ADDENDUM No. 1

REQUEST FOR QUOTATIONS (RFQ) No.:	1220-040-2024-031
TITLE:	Cloverdale Agriplex Slab on Grade Modifications
ADDENDUM ISSUE DATE:	May 21, 2024
DATE:	PREFER TO RECEIVE QUOTATIONS ON OR BEFORE MAY 28, 2024.

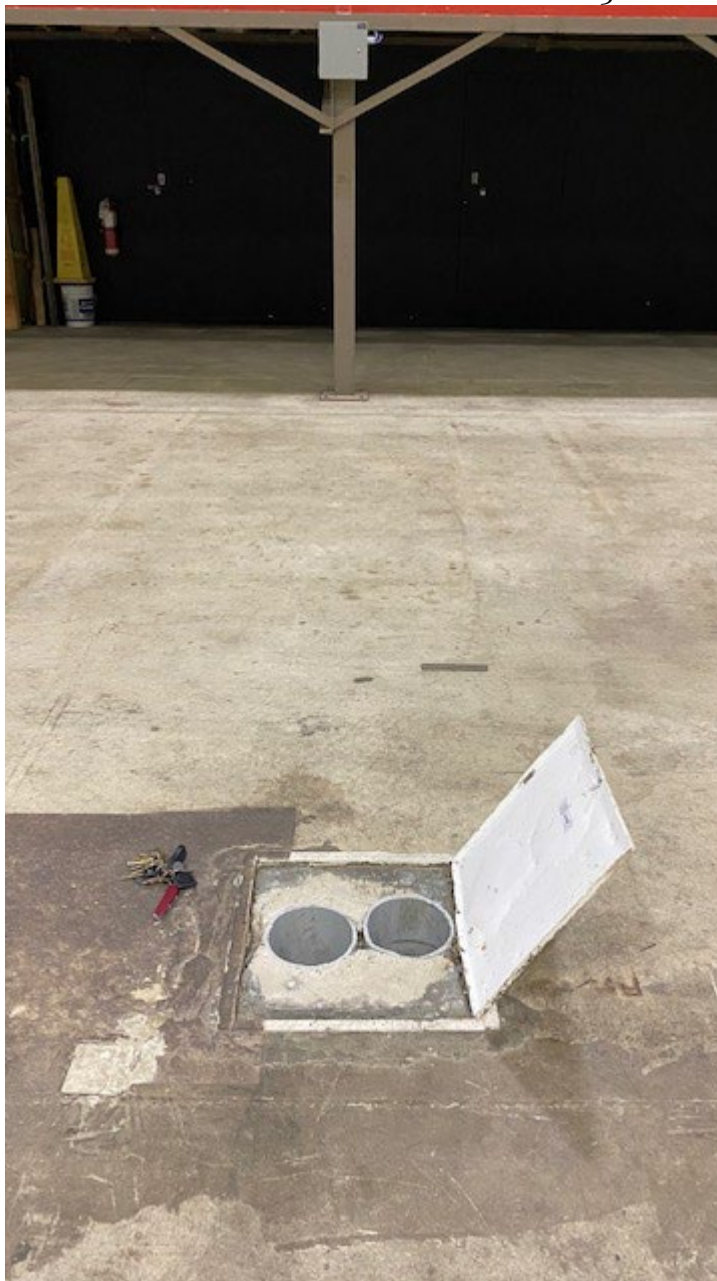
1. Regarding slab finish and flatness.

“Slab on grade is to be finished as per CAN/CSA A23.1 Class B (Ff= 25, Fl=20).”
